DESIGN REVIEW COMMISSION

July 12, 2023

Agency recommendation – Denial of new wall sign design; Recently, The Herb Shop relocated to 186 North Avenue from its former location on Tara Boulevard. The business is now proposing a hanging sign off the awning at Suite 103. I notified the owner about the permitting process. This property does not lie within any overlays or special districts. The wall sign panel (non-illuminated) hanging near the front entrance is proposed to be **20 total square feet**, which is well below the maximum 150 square feet allowed in Code Section 86-490(b) and below the 7.5% of the facade allowed. The color scheme will not be incompatible with adjacent businesses. This sign would face North Avenue.

Commission to make a recommendation for Sugar Bush Sports Bar – 7955 Tara Boulevard; Parcel No. 13210D A010; Proposed murals for existing business.

Attachment: Sign Location (3457 : 186 North Avenue Sign)

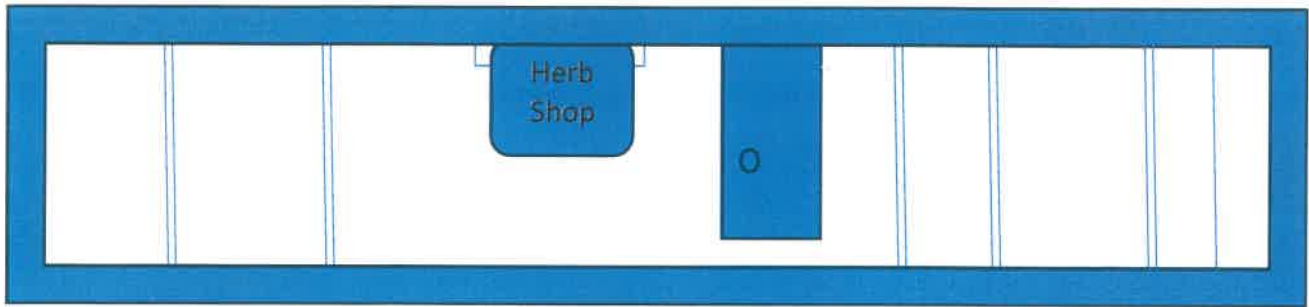
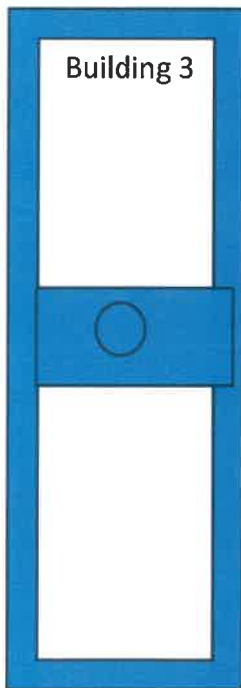
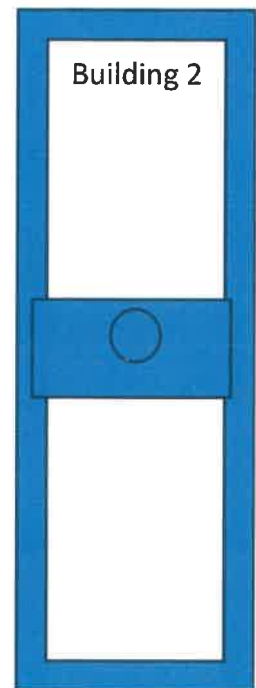
This sign will be a hanging sign, subject to the standards of Sec. 86-489 (c)(5): **(5) Hanging or suspended signs. Hanging, suspended, or projecting signs are permitted in planned centers/connected storefronts and shall clear sidewalks by seven feet in height, and project or drop no more than 36 inches from the building.** Hanging or suspended signs should project or drop from a wall or roof at a 90-degree angle. Hanging or suspending signs over driveways, alleys, or parking areas is prohibited. Hanging, suspended, or projecting signs shall be limited **to a maximum size of six square feet**, and if double sided shall be calculated as only one sign. One hanging, suspended, or projecting sign per building business street frontage is permitted, and shall be calculated as part of the total wall sign area allowed under this section. **The sign would hang over landscape bed, not the sidewalk. However, the proposed size exceeds the maximum allowable size for hanging signs. In addition, the background picture on the sign design makes the sign too busy to be seen clearly, especially from the road. Also, the white lettering gets lost in the design and cannot be read clearly.**

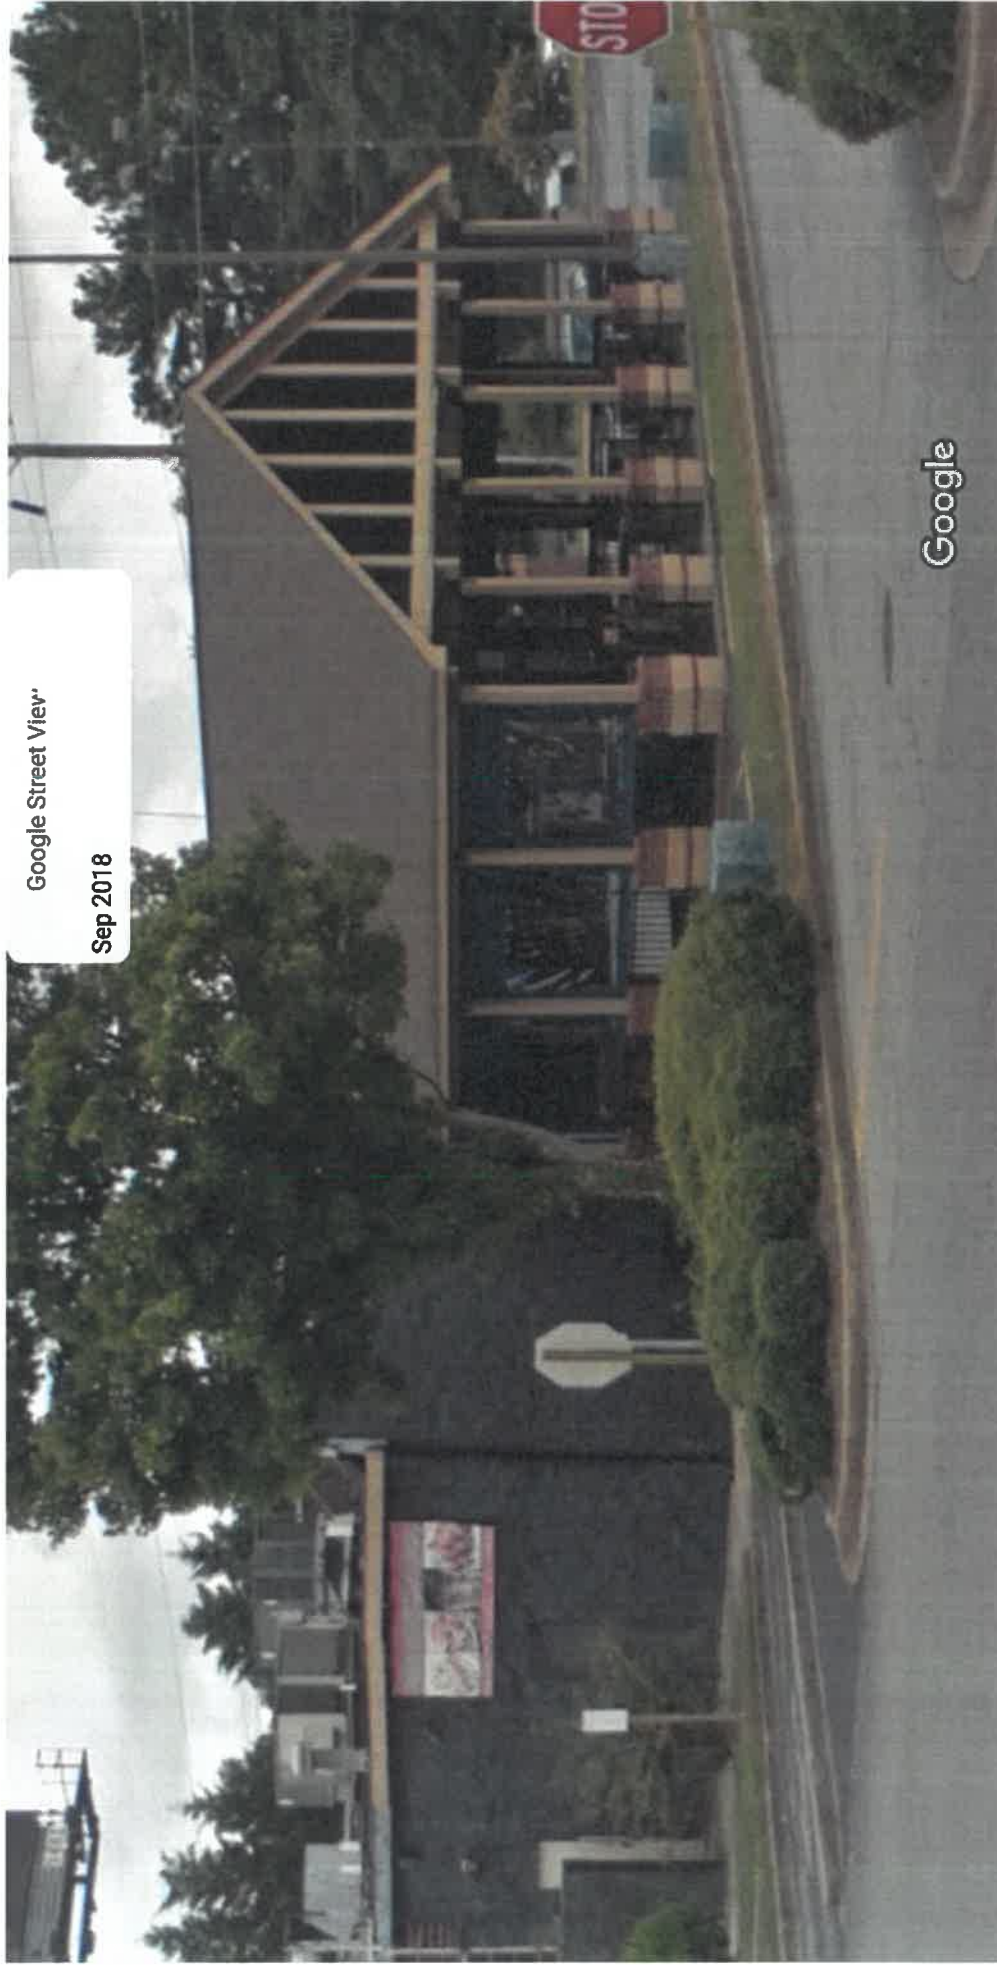
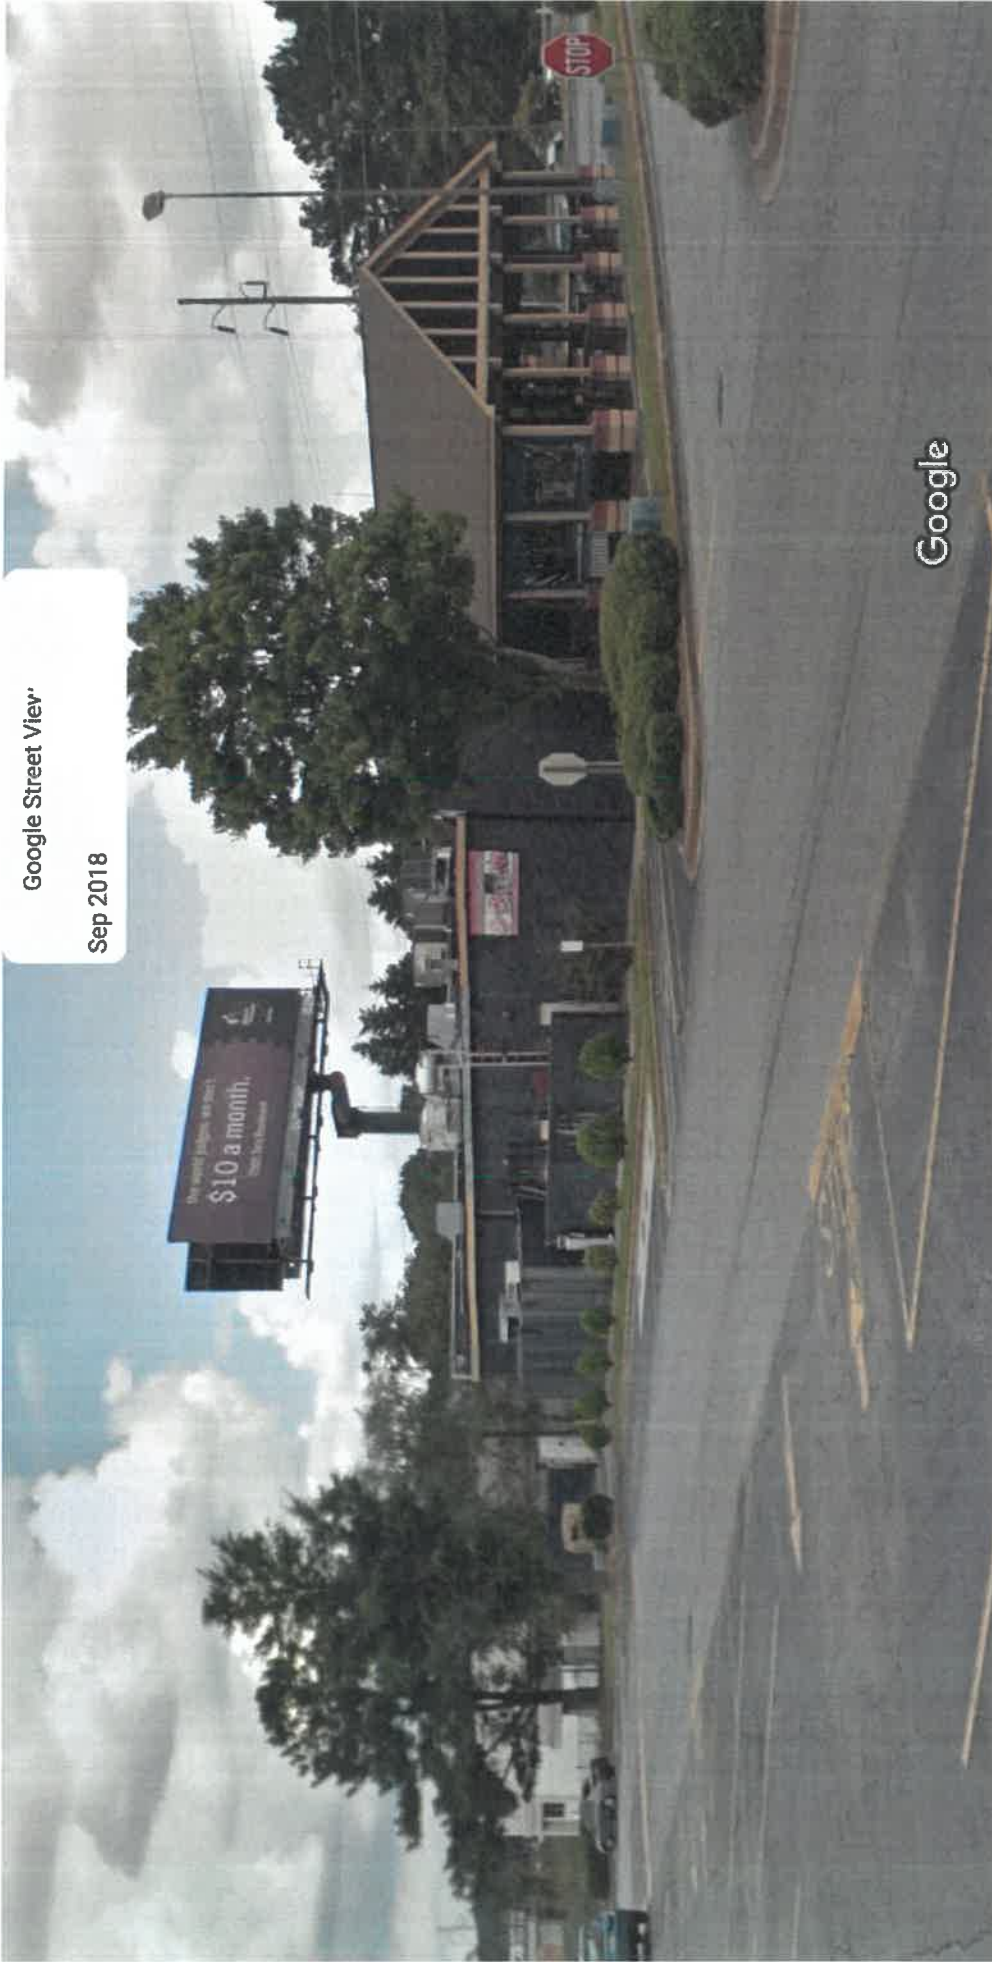
So, the bottom line is that you could only have one mural on the building, due to the fact that the building only has frontage on Tara Blvd. Also, the purple murals you show on the back of the building would be considered six separate wall signs since they would likely be separated by more than 36 inches a piece.

Design wise, the designs do not have a "finished" professional look. The applicant would need to decide on which mural to have (if any) and improve its appearance.
